**NOTICE
OSHTEMO CHARTER TOWNSHIP
ZONING BOARD OF APPEALS**

TUESDAY, MAY 25, 2021

To: Zoning Board of Appeals
From: Karen High, Zoning Administrator
Mtg Date: May 25, 2021
Applicant: Brian Thompson, Fishbeck
Owner: Meijer, Inc
Property: 6660 W Main Street, parcel number 05-14-185-022
Zoning: C: Local Business District

SITE ELECTRICAL PLAN
SCALE: 1" = 60'
NORTH

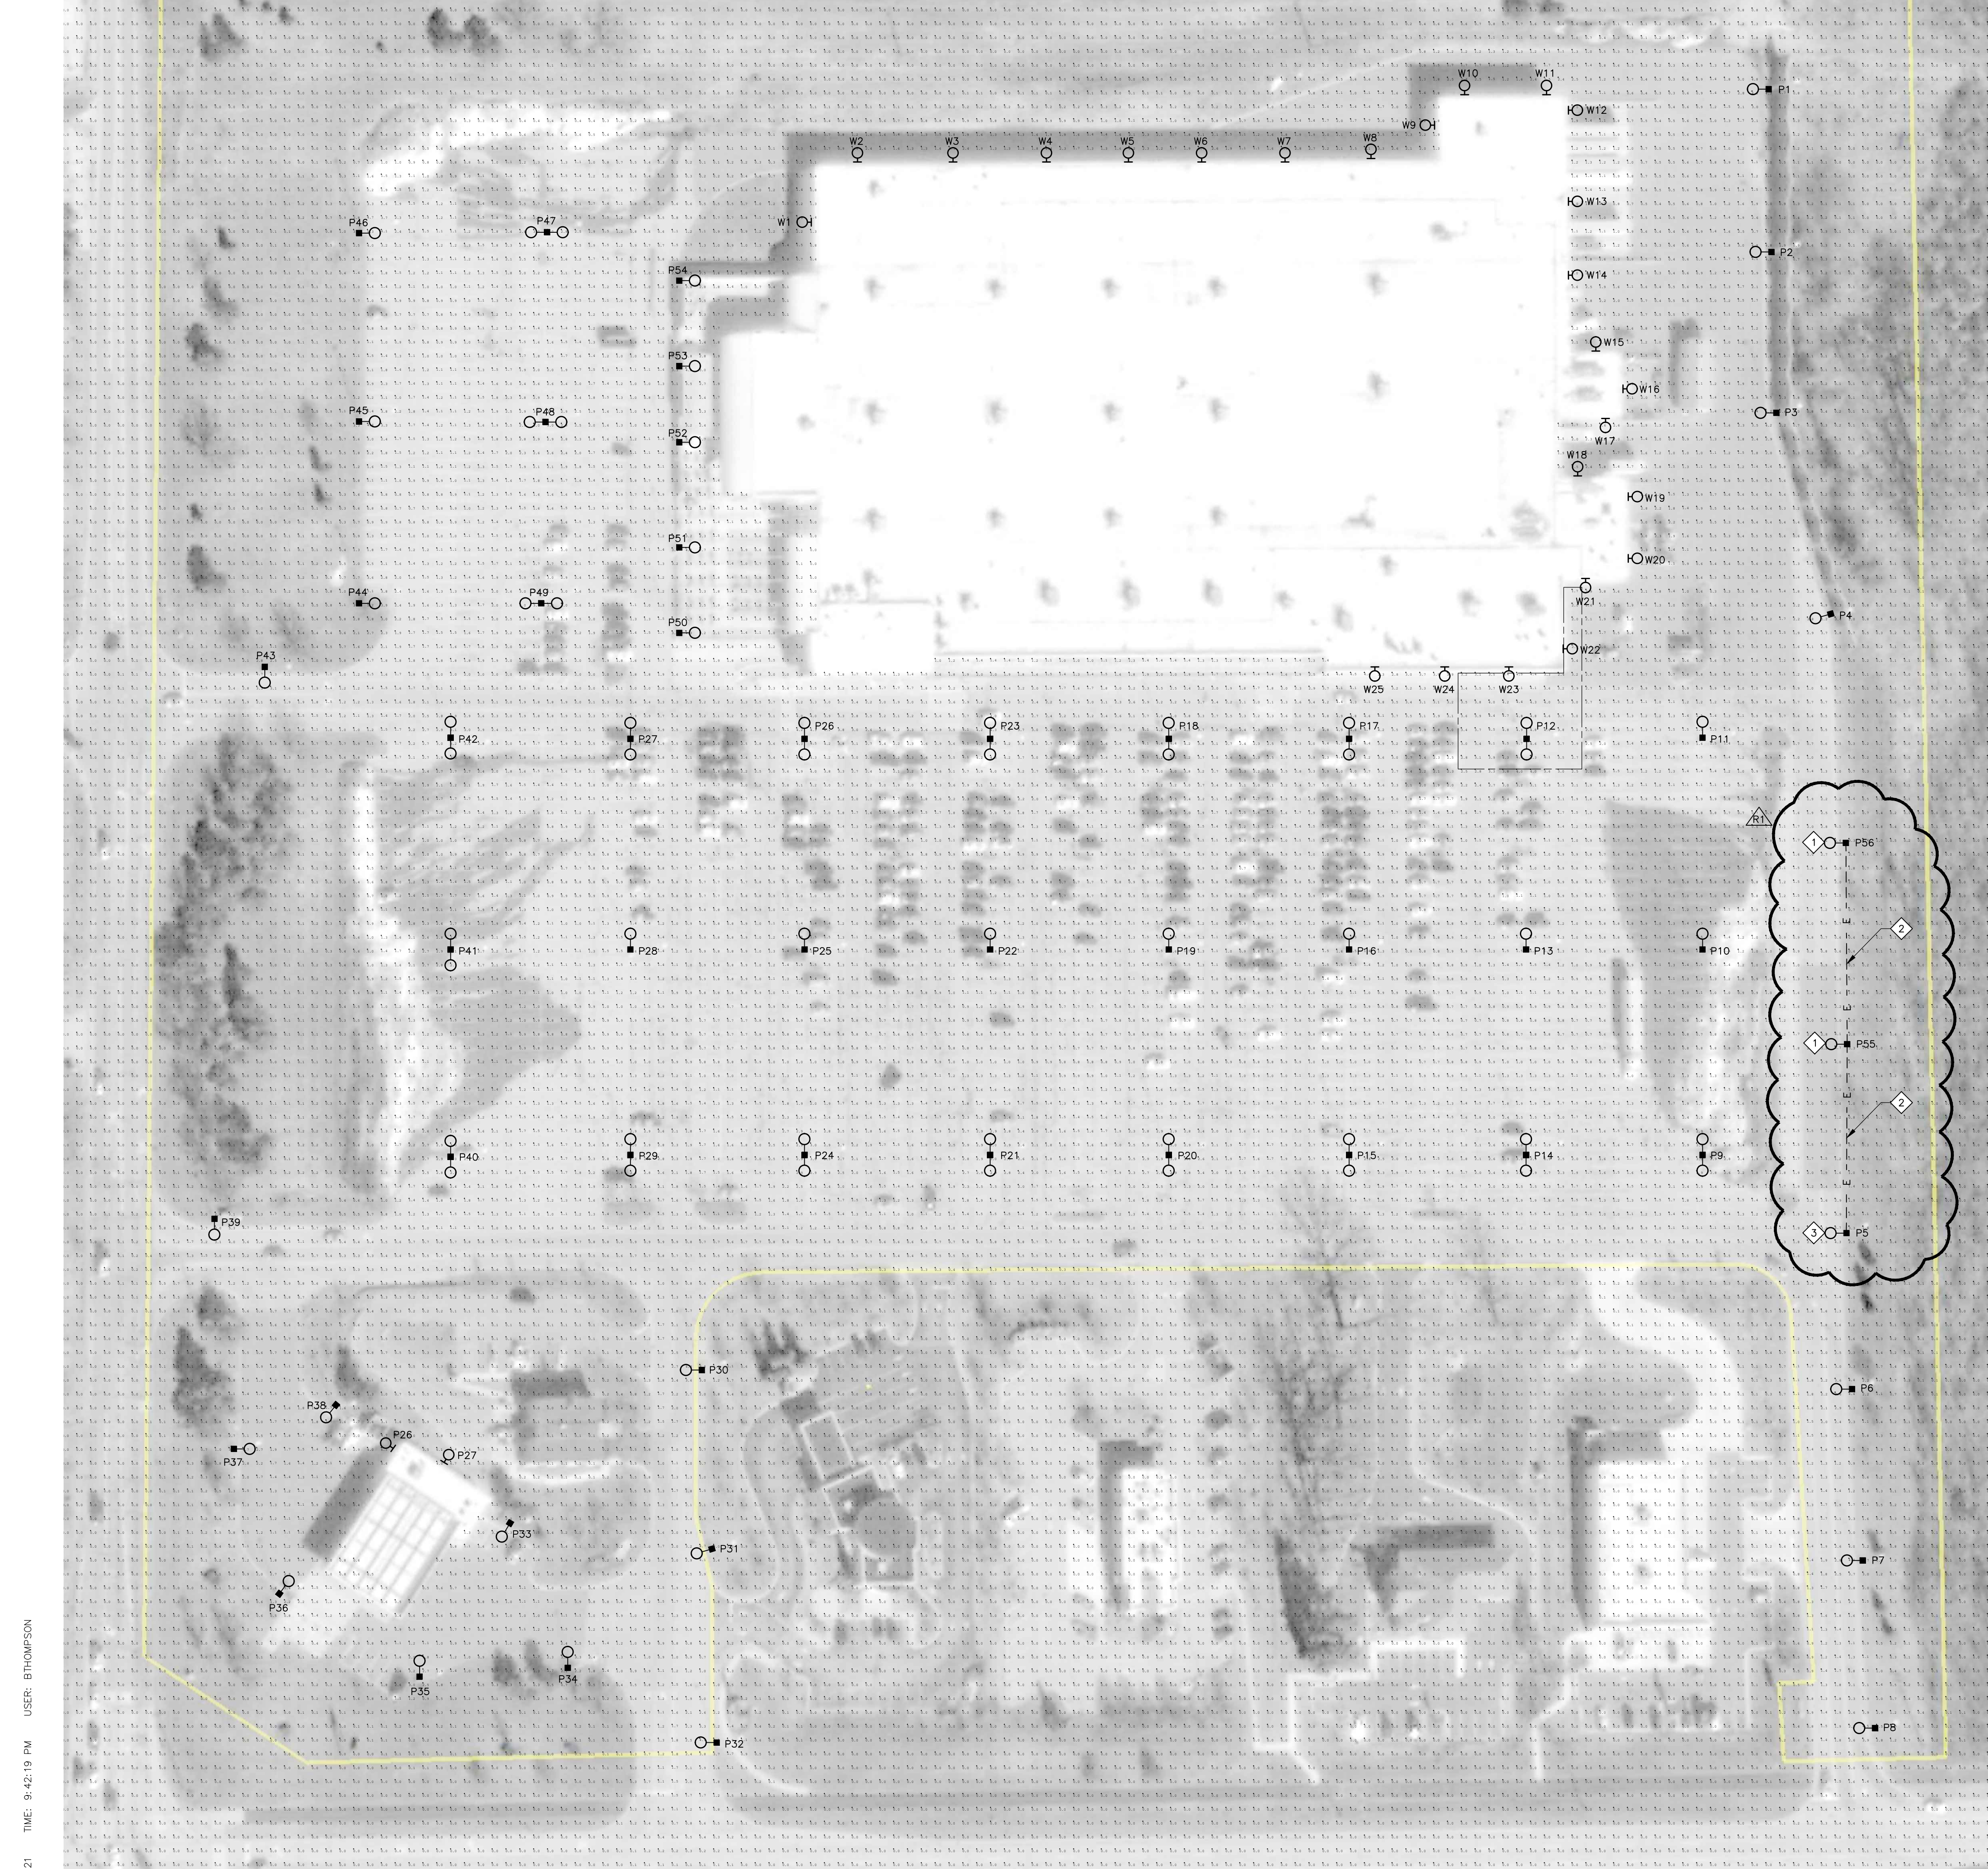
1. Allow pole-mounted luminaires to exceed the 20,000 lumen maximum at five (5) poles located directly in front of the store. These poles are circled in red on the lighting plan below. Luminaires with 26,000 lumens are proposed.
2. Allow building-mounted lights to exceed the 14' mounting height maximum. This request includes 22 fixtures located at the north and east sides of the building that illuminate the truck dock and truck circulation area. Three fixtures are located at the front of the store near the curbside pickup area, where higher light levels are desired. The applicant proposes to mount the lights at their current height of approximately 18'.

All of the pole mounted lights on the site are proposed to be replaced. Existing poles vary in height from 25' to 39'. New poles will be placed in the same locations as the existing poles, but are proposed to be 22' tall with a new 2.5' concrete pole base in order to meet the 25' mounting height requirement of our current ordinance. The lower mounting height reduces average light levels and uniformity. To address this issue the applicant proposes to increase the lumen levels of the five light fixtures closest to the building to counteract this effect and to provide the desired light levels near entry points and curbside pickup to ensure pedestrian and employee safety. The applicant could reduce the spacing between light poles in order to increase light levels and meet the ordinance. However, changing the pole spacing on this previously developed site could be considered unnecessarily burdensome as it would require redesign of the site and the addition of underground utilities.

As previously stated, 22 of the 25 wall mounted fixtures are to illuminate truck dock and truck circulation areas. The applicant suggests, and Planning Department staff agrees, that the 14' maximum mounting height does not allow for adequate lighting levels in these areas. If these areas were lit with pole mounted lights, a mounting height of 25' and 20,000 lumens would be permitted. The new wall mount fixtures are proposed to have luminaires with either 4,270 or 6,100 lumens. Our ordinance allows up to 8,000 lumens. The applicant suggests pole lights in the truck dock area could be a hazard in that the poles would block vehicular circulation. The higher building-mounted lighting is proposed to function as area lighting in lieu of additional poles in areas of high truck traffic. The three wall mounted fixtures above the entrance are proposed to remain at their existing 18' height in order to improve light levels and uniformity at the front entrance and curbside pickup area.

If the ZBA chooses this motion, staff requests that a condition be attached requiring the property owner to complete the building permit process via the Southwest Michigan Building Authority and that the Zoning Board of Appeals send a request to the Planning Commission to consider an ordinance amendment that addresses building mounted lighting to illuminate truck docks or truck circulation routes.
